Access Compliance Report

Public Rights-of-Way

(Curb Ramps)

Intersection ID: 24385	Main Street: BEVERLY_CREST_BV	Cross Street: BECKMORE_PL	Location: SW
ADA ID: EB816BEA2C64	Ramp Type: Perp	Initial Pass/Fail: Pass	Overall Compliance: No
Severity Score: 2.75			
Codes/Mitigation Info/Possible Solution		Field Measurements/Component Compliance

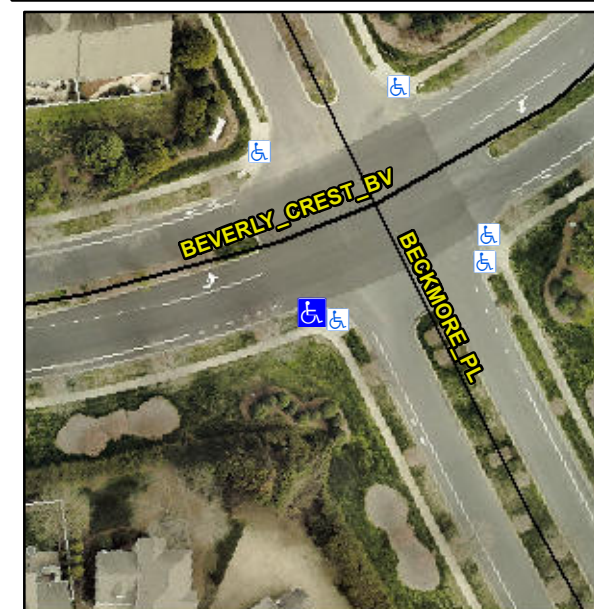
Not Found, R304.5.3, R305.1.4

Compliance	Description	Data	Compliance	Description	Data
N/A	Ramp Length (in)	85.0	Yes	Ramp Slope (%)	7.7
Yes	Ramp Width (in)	73.0	No	Ramp XSlope (%)	3.3
N/A	Flare Type LT	Sloped	N/A	Flare Type RT	N/A
N/A	Flare Slope LT (%)	3.6	Yes	Flare Slope RT (%)	7.8
N/A	Flare Traversable LT?	Yes	N/A	Flare Traversable RT?	Yes
Yes	Landing Length (in)	67.0	Yes	DWS Provided?	Yes
Yes	Landing Width (in)	73.0	Yes	DWS Contrast?	Yes
Yes	Landing Slope (%)	0.1	Yes	DWS Length (in)	25.5
No	Landing X Slope (%)	3.3	No	DWS Full Width?	No
N/A	Landing Curb? (Y/N)	No	Yes	DWS Offset (in)	1.0
N/A	Shared Landing?	No			
Yes	Gutter Ponding?	No	Yes	Gutter Slope (%)	3.2
Yes	Gutter Lip Ht (in)	0.0	No	Gutter X Slope (%)	3.4
N/A	Painted X Walk1?	No	N/A	Painted X Walk2?	N/A
	X Walk 1 Direction	To N		X Walk 2 Direction	N/A
N/A	X Walk 1 Width (in)	N/A	N/A	X Walk 2 Width (in)	N/A
	X Walk 1 Slope (%)	0.3		X Walk 2 Slope (%)	N/A
	X Walk 1 X Slope (%)	1.8		X Walk 2 X Slope (%)	N/A

**Remove & Replace Entire Ramp.
Remove & Replace Gutter.**
